ADDENDUM No. 3 REQUEST FOR TENDER ARIBA Doc3851217981 CLOSING DATE (REVISED): 12:00 NOON (LOCAL TIME), June 20, 2023 For: New Dental Clinic, Located at 240 Alton Towers Circle, Toronto

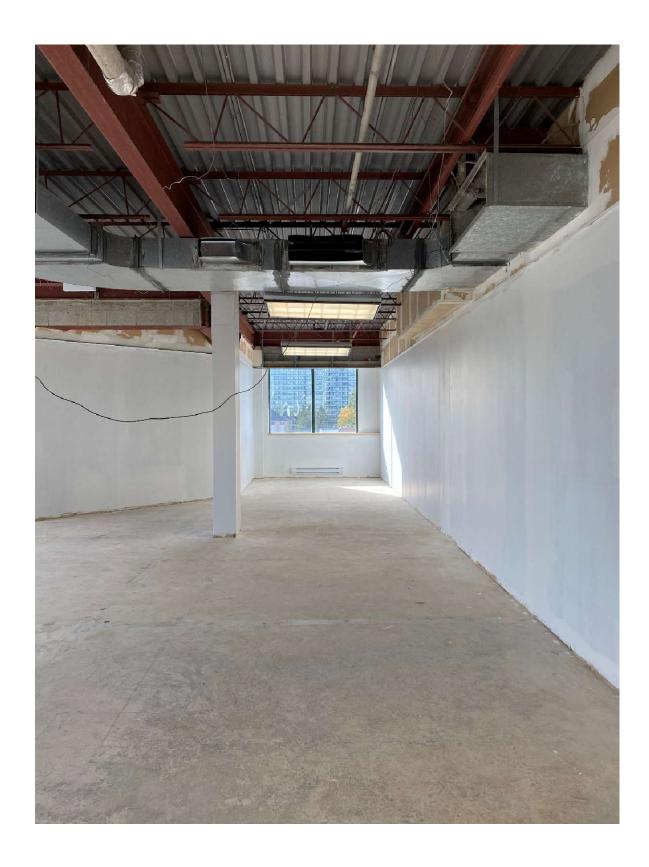
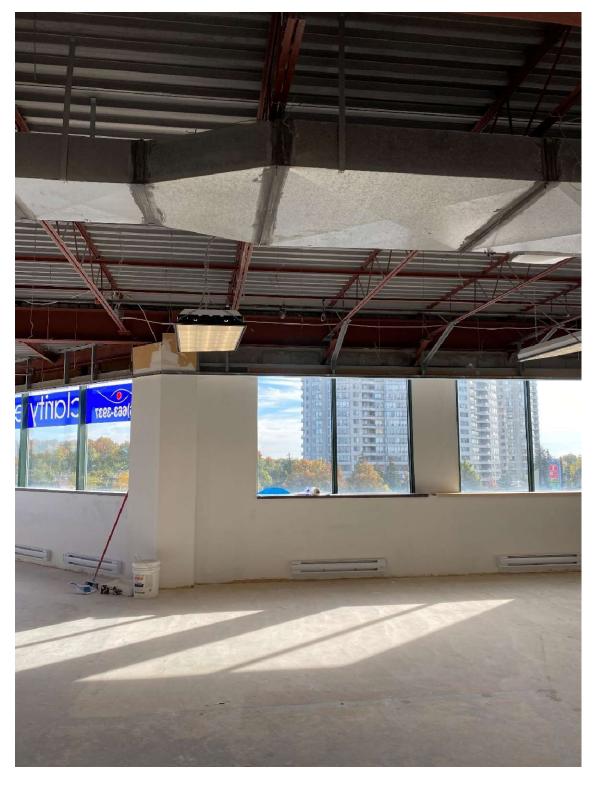
- Q3: What is the slab to deck height? I only find notes and photos referring to partitions going 12" above ceiling.
- A3: Slab to deck height is not available at this time. Contractor is to conduct site verification review and measurements prior to construction commencement. Below are photos of the existing space as reviewed together during the mandatory site visit to use as reference
